NOTIFICATION

#0002

SUBJECT: Wires overheating on Rotax 912 iS B-side voltage regulators

MODELS AFFECTED: All Sling LSA and Sling 2 aircraft fitted with Rotax 912 iS engines.

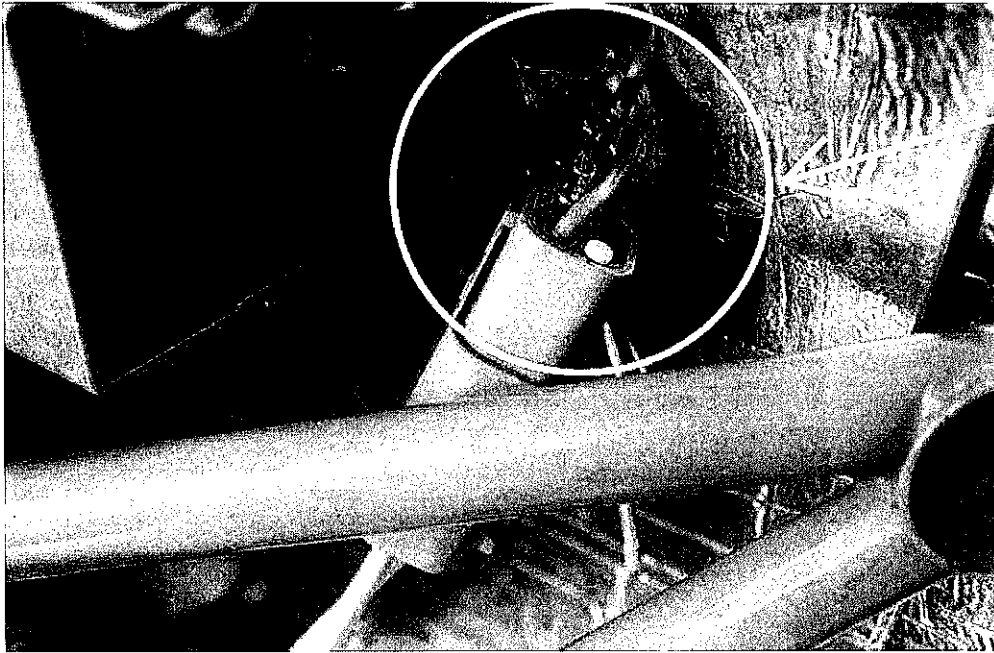
Before each flight the condition of the yellow wires running to the B-voltage regulator must be checked for discoloration. This can be done through the left-hand inspection door on the top engine cowling. (See attached photographs), with the exception of the following aircraft serial numbers:

Discolored Wires

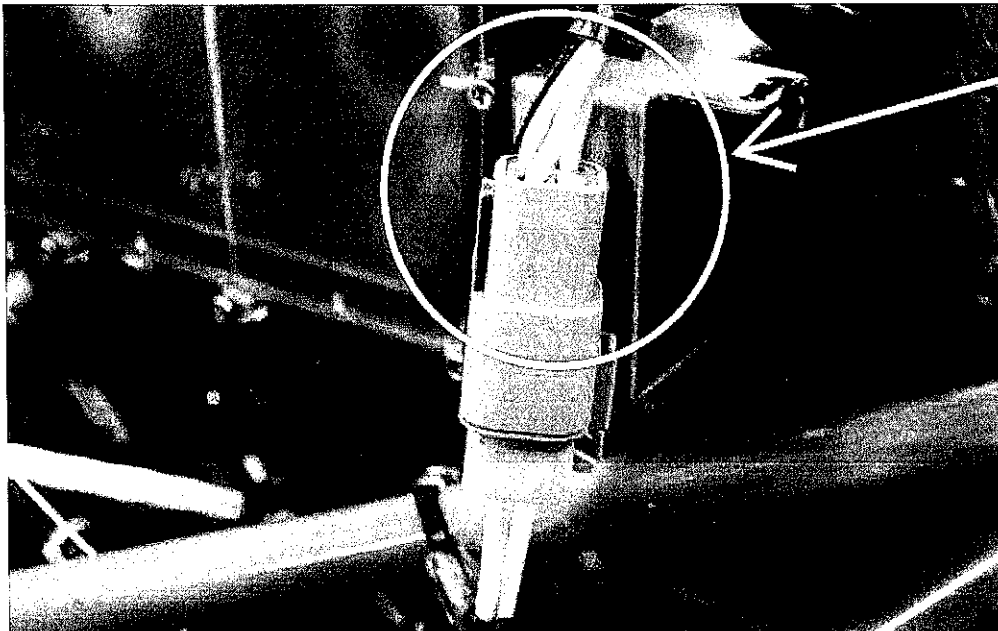
In the photograph below the discoloration is evident. Note the brown color of the brittle overheated wires.

Should melted wires be noticed, it is recommended that the aircraft not be flown and The Airplane Factory, TAF distributor or the nearest Rotax Service Centre be contacted for assistance.
